United States
Consumer Product Safety Commission

Ballot Vote Sheet

SUBJECT: Final Rule: Safety Standard for Adult Portable Bed Rails

DATE: June 28, 2023

Illustration from Figure 2 of ASTM F3186 – 17, Section 6.4

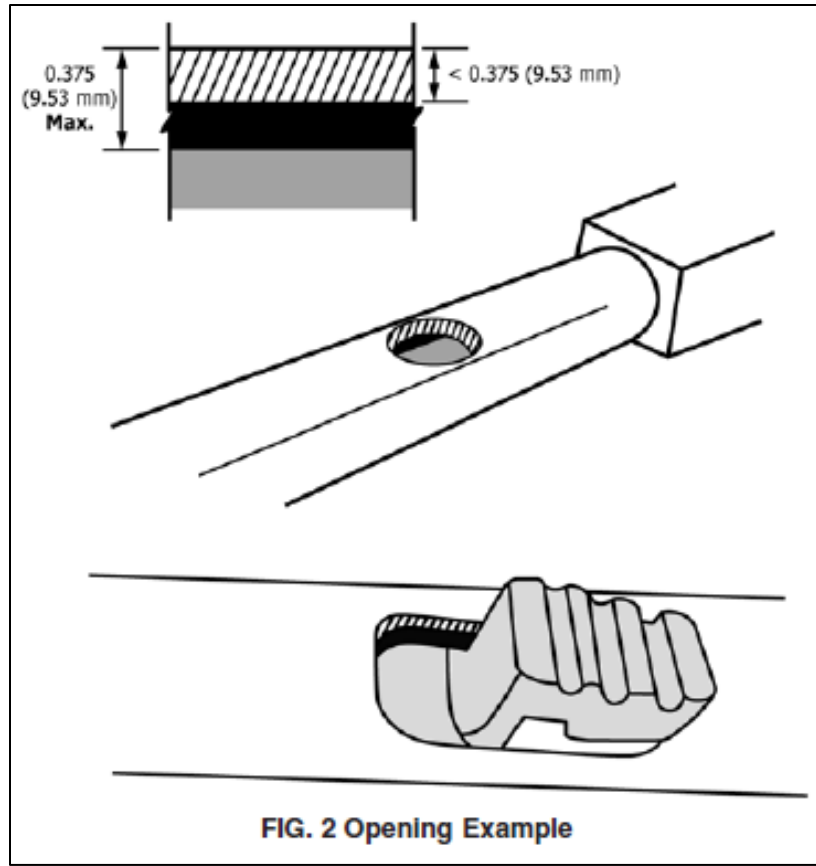
Comment: Louis A. Ferreira, of Stoel Rives, LLP, representing Stander, Inc. (Stander), a seller of APBRs, suggests that the NPR’s proposal to regulate the sizes of holes or slots that extend entirely through a wall section on an APBR is not reasonably necessary to prevent or reduce an unreasonable risk of injury. Stander disagreed with the Commission’s proposal to make the opening requirements consistent with standards for other products such as Children’s Portable Bed Rails and instead suggests that the final rule should only correct consistency errors concerning dimensions in Section 6.4 of the voluntary standard. Stander claimed that “the size of the holes do[es] not increase the risk of a fall or entrapment” and that “[t]here is not even evidence in the record that would support a conclusion that finger entrapment in the holes of an adult bed rail have ever caused an injury.”

Section 6.4 of ASTM F3186-17 addresses the risk of finger entrapment and laceration in small holes or openings. Changes to this section are necessary to correct errors and inconsistent measurement references. Specifically, in stating the dimensions of the rods used to conduct testing, the standard inaccurately refers to 13 mm as the equivalent to 5/8 in. (whereas 5/8 in. is approximately 16 mm). Also, while the standard allows different dimensions for holes or slots that do not exceed ¼ in. in depth, it refers to a drawing depicting a hole up to “.375 (9.53 mm) deep,” or 3/8 in., shown below in Figure 2.

Further, the proposed changes in the NPR are necessary to adequately address the risk of injury because the hole dimensions referenced by the commenter are not effective in protecting vulnerable adult populations. Vulnerable adults are often smaller and more frail than other populations of adults and are more likely to use APBR products. The proposed changes in the NPR align the rule with other established children's product regulations that prevent hazards to a range of finger sizes that covers both children and adult users simultaneously.²²

The Commission therefore concludes the language proposed in the NPR is necessary to address the range of foreseeable consumer exposures to potentially hazardous holes in APBRs. Therefore, no change will be made to the final rule based on this comment.

Figure 1 of Final Rule: General example of areas subject to Zone 2 requirements.

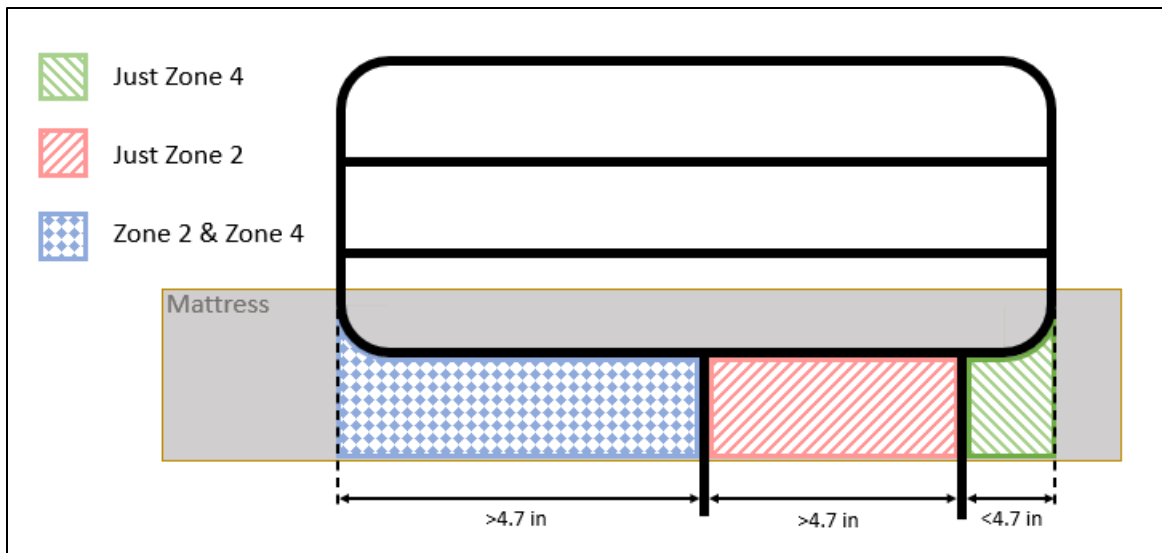
Comment: Luis A. Ferreira, representing Stander, suggested that staff’s proposed entrapment test modifications are ambiguous and inadequate. Stander expresses concern “that the ASTM Standard with the proposed modifications could be misinterpreted, and a product fail the test, not because of any unreasonable risk posed by the bed rail, but simply because a mattress is selected for testing that is so soft that the probe can be pulled beneath the bottom rail of the APBR.” Stander suggests making changes to the proposed entrapment test requirements of the NPR.

We disagree with Stander's interpretations that entrapment zone hazards only exist where there are visible openings. According to the CPSC staff's analysis of the incident data, the area "between the rail and mattress" is the most common location for entrapment. The hazards related to each zone are present regardless of the locations of the supports but are dependent on the design of the rail in relation to the anthropometric dimensions of the user.

For example, per Zone 2, the known hazard is head-first entry under the rail in any section longer than the anthropometric head dimension of the entrapment test probe, which is 4.7 inches. Therefore, in Figure 1 of the final rule below, both the left and right areas should meet Zone 2 requirements, in addition to the other applicable tests, to ensure the product adequately addresses the known hazard.

Safety testing should represent known hazard modes, including the displacement caused by consumers moving or pushing into the mattress or product, which may create an opening that was not previously visible. During entrapment zone testing, the positioning and application of the force via a force gauge must be realistic and representative of all reasonably foreseeable scenarios of consumer behavior. In many cases, applying the force to the probe by attaching a force gauge below the bottom of the rail is the most accurate representation of the worst case of this foreseeable hazard scenario. Additionally, in contrast to the current voluntary standard, entrapment hazards are not present only in the “largest opening” of a product. Entrapment hazards may exist in several areas depending on the product configuration and installation. To ensure entrapment hazards are adequately addressed, products must be assessed in all areas that may constitute an entrapment zone. Therefore, in response to this comment, the Commission has revised the language in the final rule as follows:

- Adding a global definition for “Entrapment Zone” to the draft rule, which will clarify what areas must be tested.

Figure 1: General example of areas subject to Zone 2 requirements.

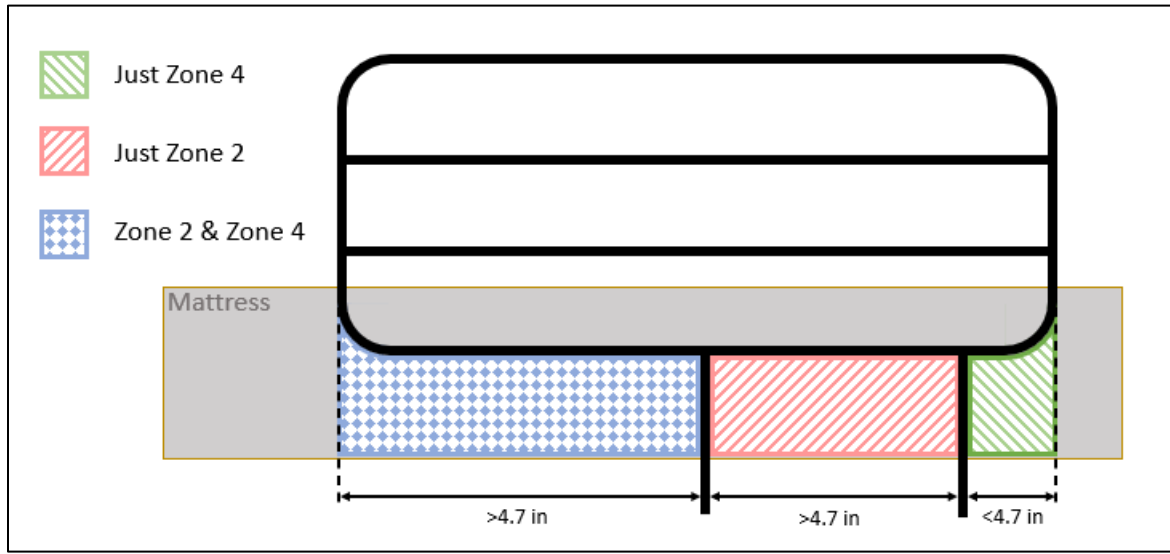
Additionally, section 1270(b)(14)(i) in the final rule has been revised from proposed 1270(b)(13)(ii). Stander raised concerns about the location of Zone 2 on bed rails with multiple supports. Zone 2 testing is meant to address head-first entry under the rail into any opening between the mattress compressed by the weight of a consumer’s head and a section of the bedrail. Bed rails that have overhanging elements longer than 4.7 inches can allow the passage of the head in a manner consistent with identified Zone 2 entrapment hazards regardless of the number or location of vertical support rails. 4.7 inches is the diameter of the test probe and encompasses the 5th percentile female head breadth. Therefore, revised section 1270(b)(14)(i) clarifies which areas should be included in Zone 2 testing along with adding a new figure 1 illustration that visually depicts the clarifying language.

(i) If a horizontal section of the rail greater than 4.7 in exists along the bottom of the rail, that section must also meet the Zone 2 requirements regardless of the number or location of the supports. Repeat testing described in sections 8.4.4.3 (see paragraph (12)(i)) and 8.4.4.4 (see paragraph (13)(i)) for all applicable entrapment zones. Figure 1 below shows a general example of areas subject to Zone 2 requirements.

Figure 2: Illustration from Figure 2 of ASTM F3186 – 17, Section 6.4

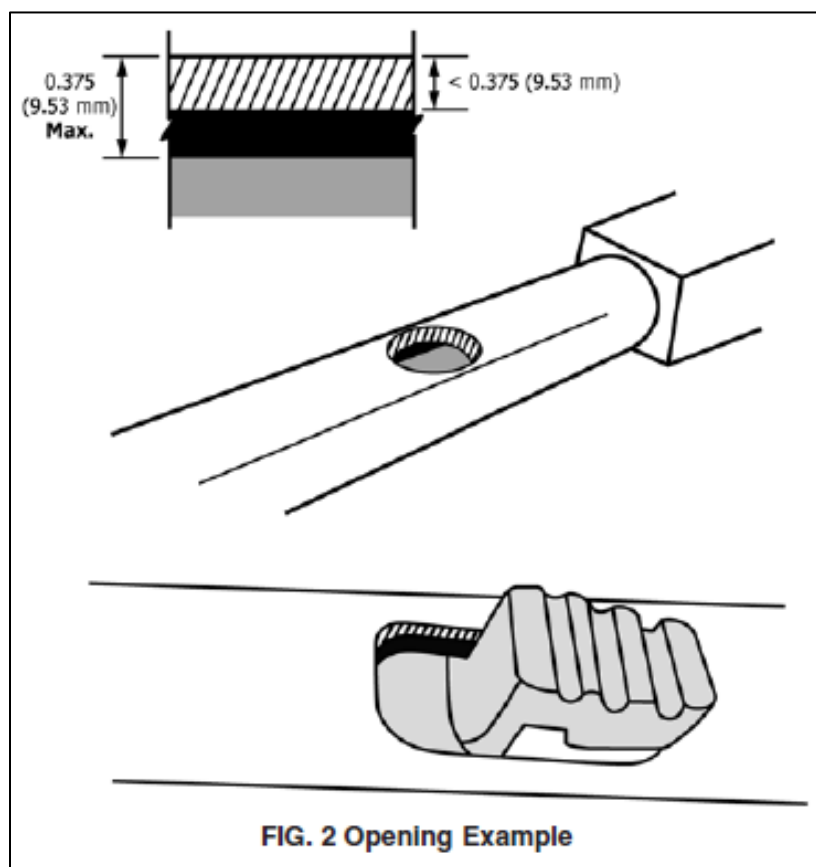
Staff Response: As reported in Tab A of the NPR briefing package, about 7,400 of the estimated 79,500 adult bed rail-related injuries treated in emergency departments from 2003 to 2021 were hand or finger injuries. Of these, about 3,400 were identified as injuries to fingers, most of which involved crushing or laceration.⁵⁷

Section 6.4 of ASTM F3186 – 17 addresses the risk of finger entrapment and laceration in small holes or openings. Changes to this section are necessary to correct errors and inconsistent measurement references. Specifically, in stating the dimensions of the rods used to conduct testing, the standard inaccurately refers to 13 mm as the correct equivalent to 5/8 in. (5/8 in. is approximately 16 mm); and, while the standard allows different dimensions for holes or slots that do not exceed 1/4 in. in depth, it refers to a drawing depicting a hole up to “.375 (9.53 mm) deep,” or 3/8 in., shown below in Figure 2.

Figure 3: General example of areas subject to Zone 2 requirements.

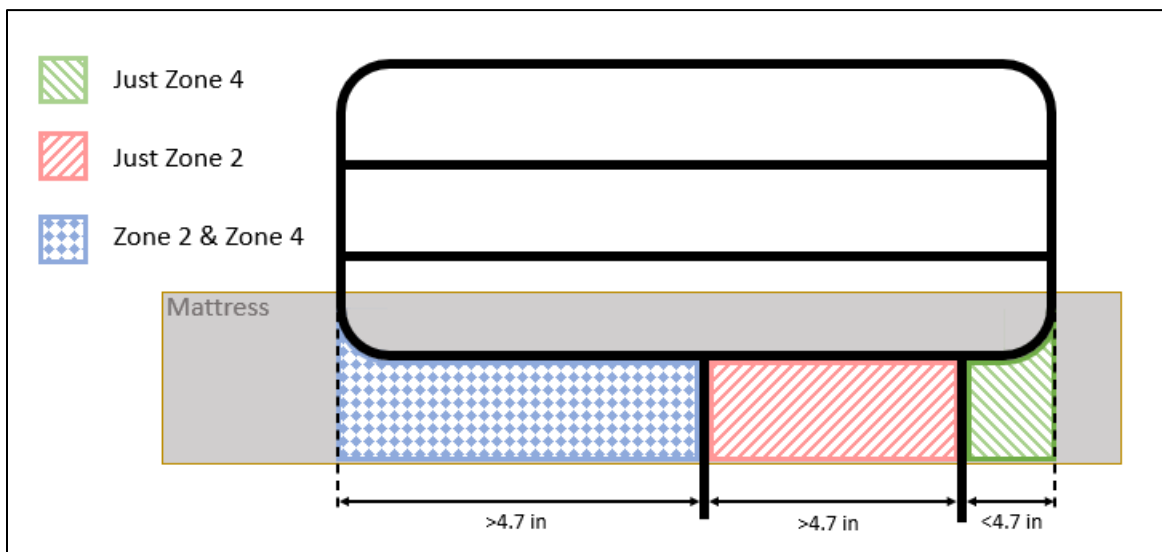
Staff disagrees with Stander's interpretations that entrapment zone hazards only exist where there are visible openings. According to the CPSC's analysis of the incident data, the area "between the rail and mattress" is the most common location for entrapment. The hazards related to each zone are present regardless of the locations of the supports but are dependent on the shape of the rail in relation to the anthropometric dimensions of the user.

For example, per Zone 2, the known hazard is head-first entry under the rail in any section longer than the anthropometric head dimension of the entrapment test probe, which is 4.7 inches. Therefore, in Figure 3 below, both the red and blue areas should meet Zone 2 requirements, in addition to the other applicable tests, to ensure the product adequately addresses the known hazard.

Safety testing should represent known hazard modes, including the displacement caused by consumers moving or pushing into the mattress or product which may create an opening that was not previously visible. During entrapment zone testing, the positioning and application of the force via a force gauge must be realistic and representative of all reasonably foreseeable

Figure 1: General example of areas subject to Zone 2 requirements.

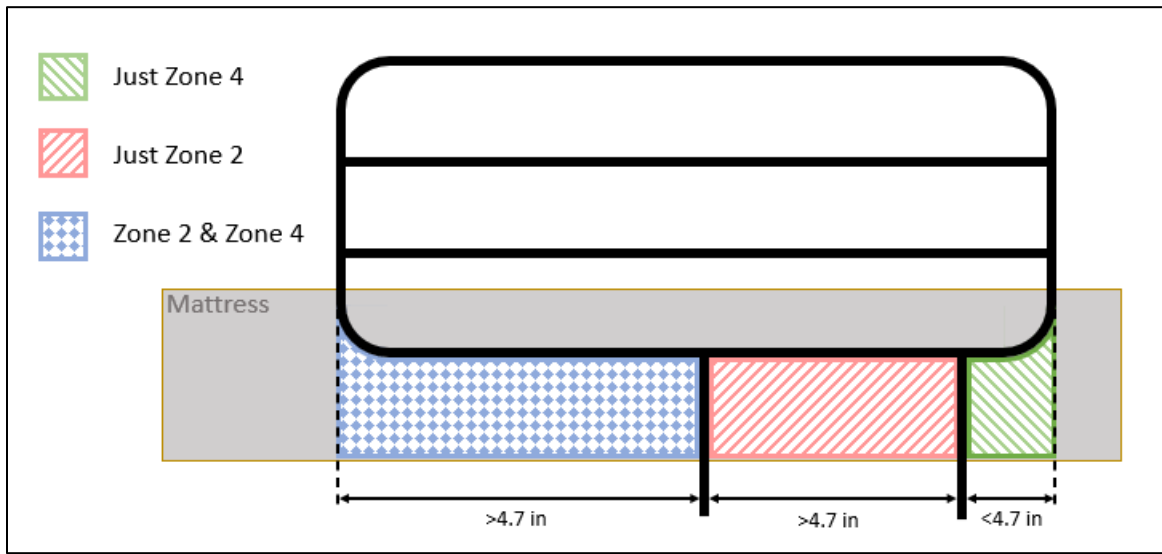
Rationale: In response to the NPR, a commenter brought up concerns about the location of zone 2 on bed rails with multiple supports. Zone 2 testing is meant to address head-first entry under the rail into any opening between the mattress compressed by the weight of a consumer's head and a section of the bedrail. Bed rails that have overhanging elements longer than 4.7 inches can allow the passage of the head in a manner consistent with identified Zone 2 entrapment hazards regardless of the number or location of vertical support rails. 4.7 inches is the diameter of the test probe and encompasses the 5th percentile female head breadth. This language and figure clarify all areas that should be included in Zone 2 testing.

- (ii) Under section 8.4.4.5, if an entrapment zone greater than 4.7 in exists along the bottom of the rail, that section must meet the Zone 2 requirements regardless of the number or location of the supports. Repeat testing described in sections 8.4.4.3 and 8.4.4.4 for all applicable entrapment zones. Figure 1 below shows a general example of areas subject to Zone 2 requirements.

Figure 1: General example of areas subject to Zone 2 requirements.

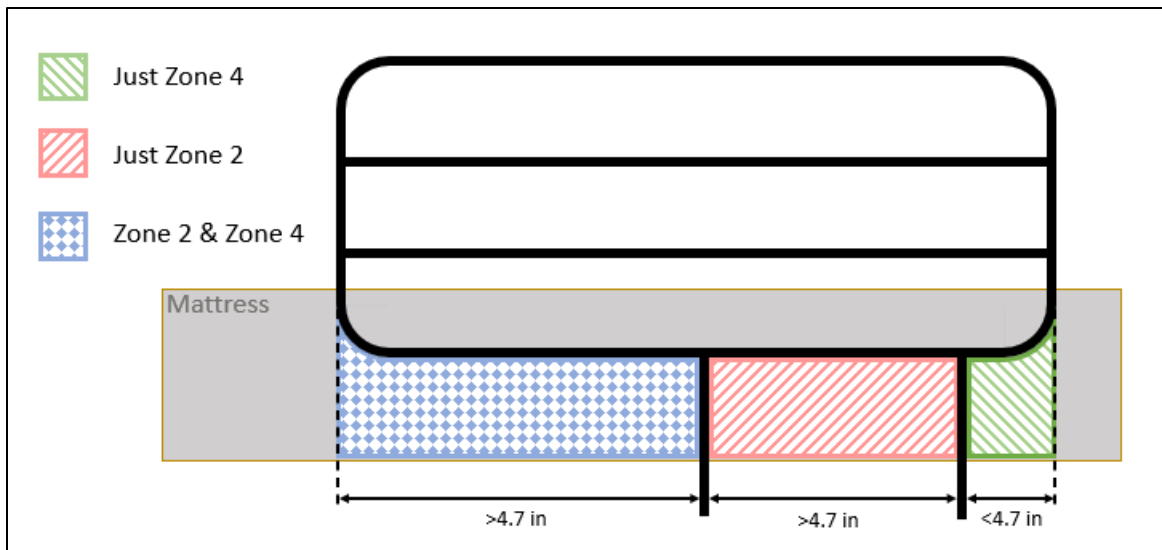
Rationale: In response to the NPR, a commenter brought up concerns about the location of zone 2 on bed rails with multiple supports. Zone 2 testing is meant to address head-first entry under the rail into any opening between the mattress compressed by the weight of a consumer's head and a section of the bedrail. Bed rails that have overhanging elements longer than 4.7 inches can allow the passage of the head in a manner consistent with identified Zone 2 entrapment hazards regardless of the number or location of vertical support rails. 4.7 inches is the diameter of the test probe and encompasses the 5th percentile female head breadth. This language and figure clarify all areas that should be included in Zone 2 testing.

- (i) Under section 8.4.4.5, if an entrapment zone greater than 4.7 in exists along the bottom of the rail, that section must meet the Zone 2 requirements regardless of the number or location of the supports. Repeat testing described in sections 8.4.4.3 and 8.4.4.4 for all applicable entrapment zones. Figure 1 below shows a general example of areas subject to Zone 2 requirements.

Figure 2: Zone 3 test: (a) **Pass**, (b) **Fail**

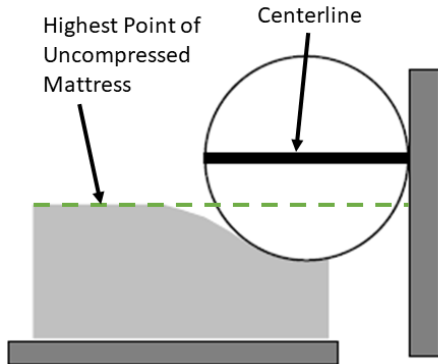
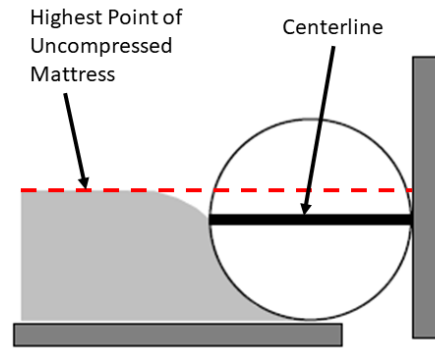
Rationale: The Zone 3 entrapment performance requirement in section 6.3.3 is redundant due to the failure criteria described in the associated test method, section 8.4.5.4. The failure criteria described in the test method is the intended requirement, which would also be more consistent with the FDA guidance document referenced in the standard and is the interpretation in favor of safety. In addition, the Figures are included to assist testers in visualizing the test criteria.

- (i) Under section 8.4.5.4, turn the cone until the line on the face of the 4.7 in (120 mm) end is horizontal and let the cone sink into the space by its own weight.
 - (A) If the line on the face of the 4.7 in (120 mm) end of the cone is above the highest point of the uncompressed mattress, as shown in Figure 2a, the space passes the test.
 - (B) If the line on the face of the 4.7 in (120 mm) end of the cone is at or below the highest point of the uncompressed mattress, as shown in Figure 2b, the space fails the test.
